SPD DATA REQUEST: SPD-SDGE-WMP2026-02
SDG&E RESPONSE

Date Received: 07-01-2025
Date Submitted: 07-16-2025

Figure 1: SUG Mitigation Effectiveness Based on All Ignition-Related Events

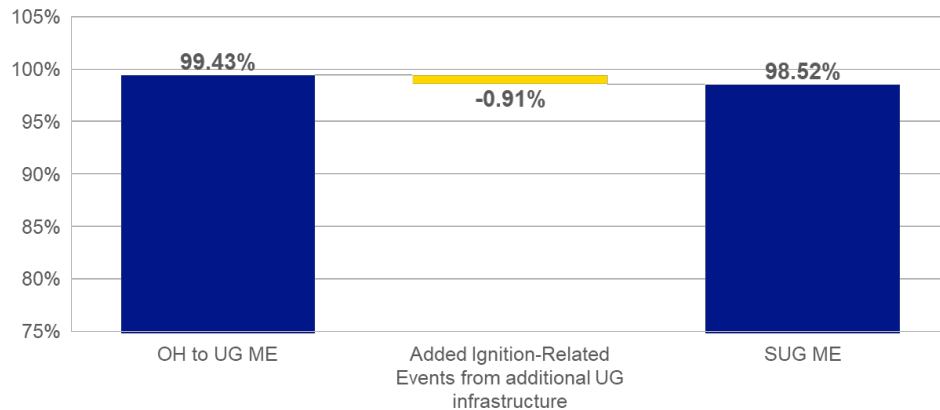
- b. Correct the mitigation effectiveness calculation to fix the arithmetic error which conflates the drivers for outage ignitions. The chart computes the mitigation effectiveness of undergrounding by comparing the number of ignitions from drivers before versus after being mitigated. However, the chart adds the drivers of underground ignitions to the drivers overhead ignitions, as an “ignition being mitigated.” These drivers of undergrounding ignitions will not be mitigated by undergrounding. In fact – the newly undergrounded lines will now be subject to these new set of underground ignition drivers – and so the number of undergrounding related ignitions to increase as lines are undergrounded.

After incorporating the estimated residual risk, the adjusted Mitigation Effectiveness of SDG&E's Strategic Undergrounding program is calculated at 98.52% (99.43% - 0.91%) as shown in Figure 1. This value is based on ignition-related events recorded between 2019 and 2024, reflecting a comprehensive assessment of both the benefits of removing overhead infrastructure and the minimal ignition-related risk introduced by underground systems.

Note that in the interest of maintaining a conservative modeling approach, SDG&E has elected to assume and model a mitigation effectiveness for SUG of 98% in its WiNGS-Planning risk analysis, instead of the calculated value of 98.52%.
